Traffic Orders – Pencoed Primary School Penprysg Road

Consultation Plan

30 Penprysg Road

Circa 1875

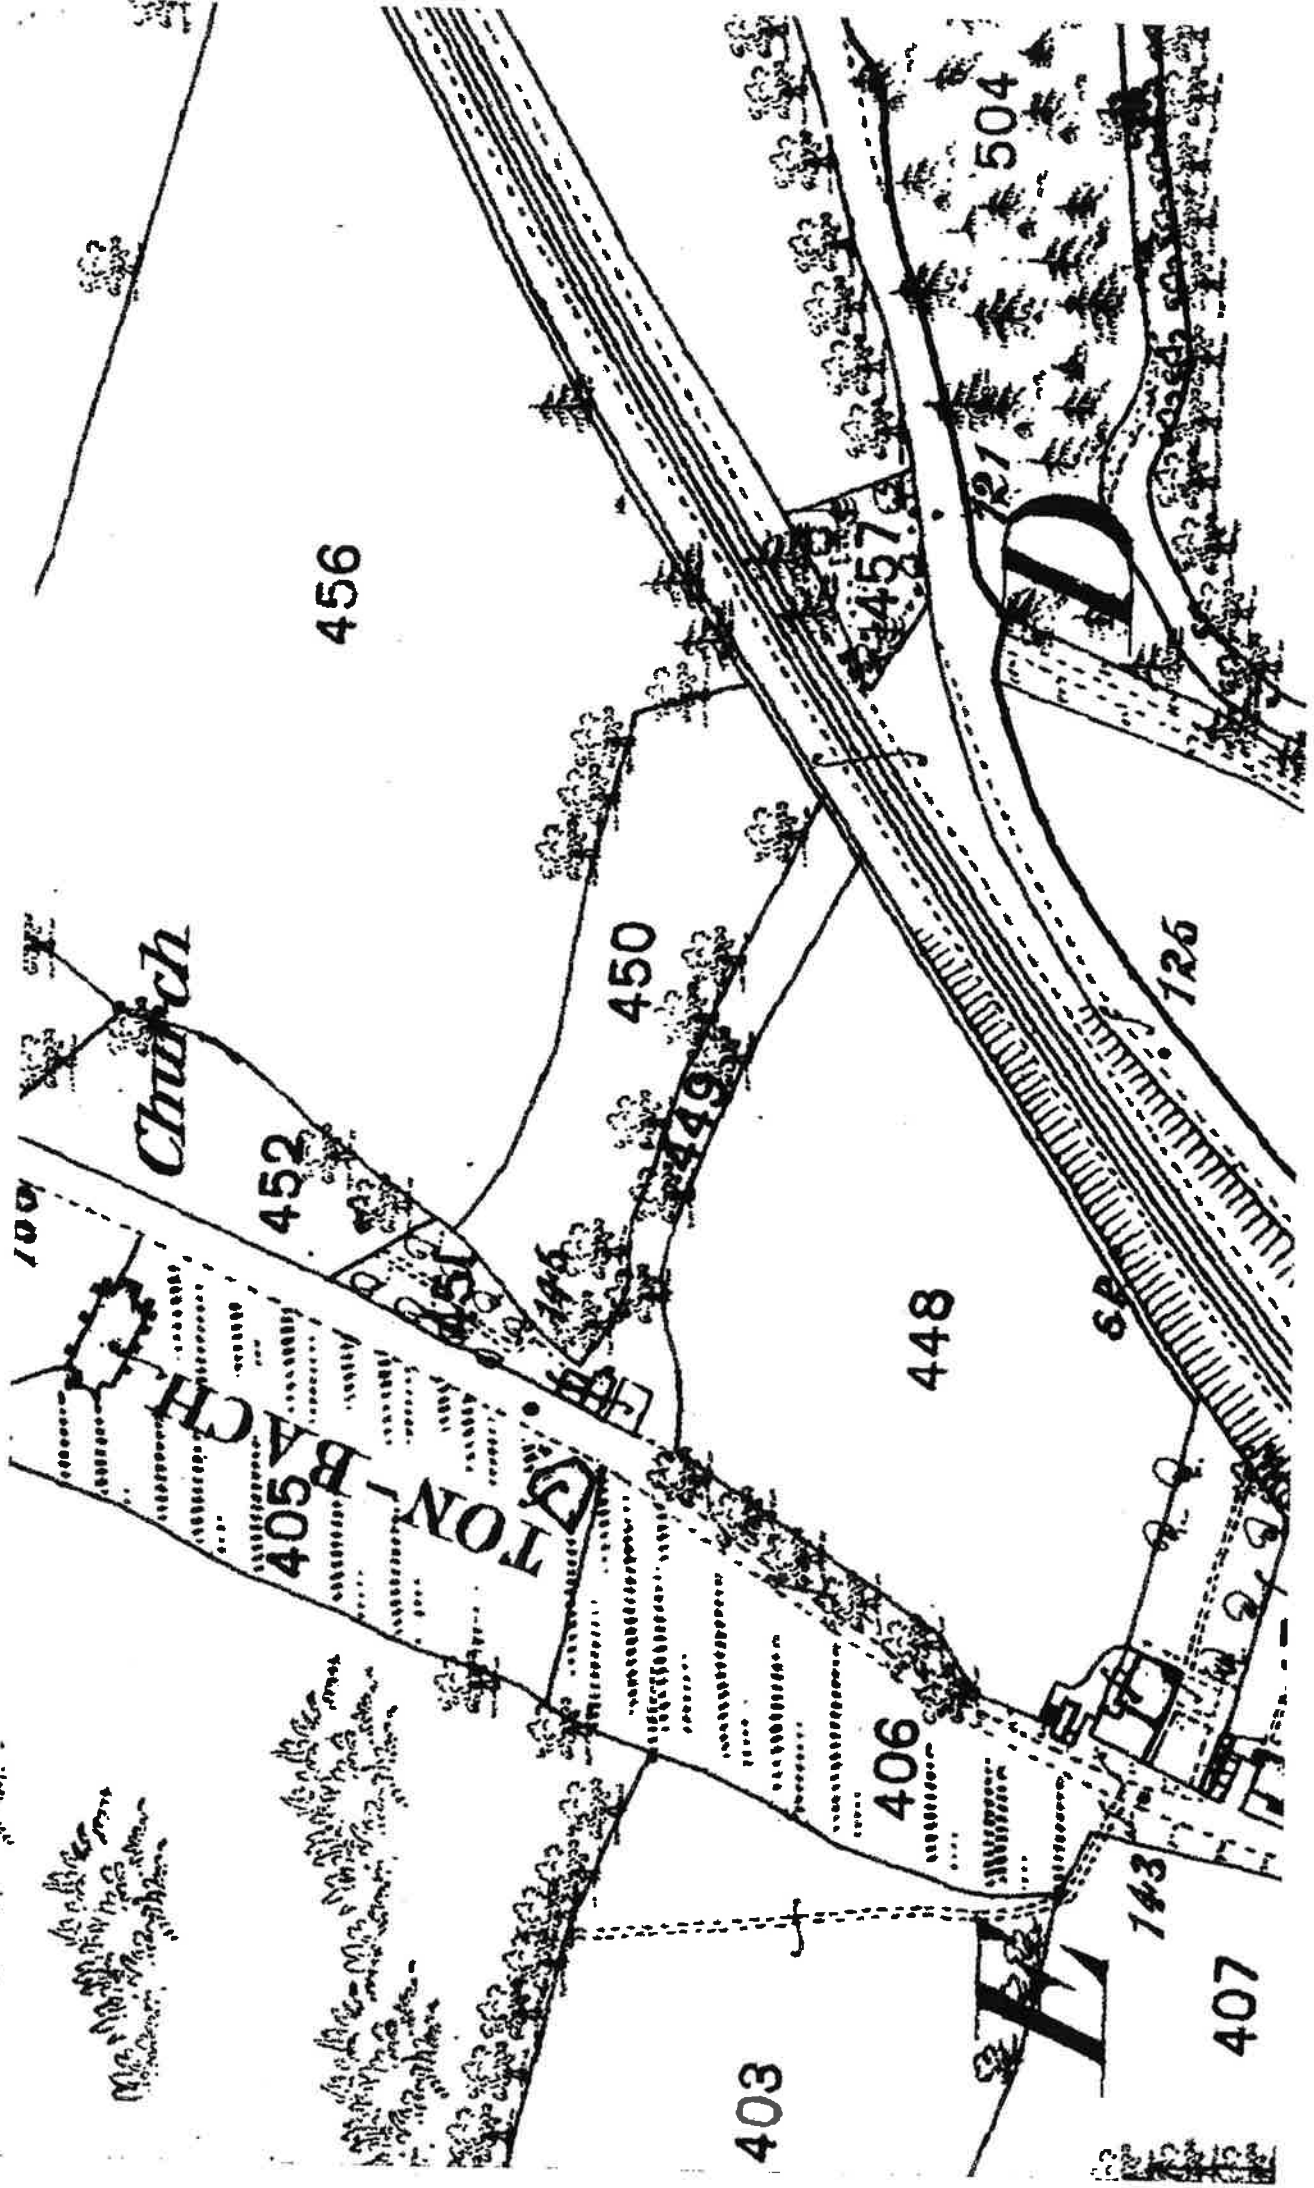
30 Penprysg Road "The Chain" was a Toll House. The garden to 30 Penprysg Road was the toll road that linked Ton-Bach with Bont-newydd. The Chain ceased to be a Toll House at around 1860 when the railway was constructed. The subsequent road improvements to what is now Penprysg Road have resulted in the North West corner of the property being 0.8 metre (31.5 inches) below pavement level. This salient item is not included in the Capita Condition Survey that includes other assumptions. I enclose a Part Copy of an Ordnance Survey Plan circa 1875.

With the above in mind, it should be noted, that during even moderate storms the accumulated highway drainage that occurs over runs the catchment gully situated at the South Boundary to my property. The proposed traffic calming construction as shown on the Consultation Plan in effect creates a dam that will impede the storm flow and has every possibility of causing flooding, and/or extreme dampness to my Home that has been in existence for at least 200 years.
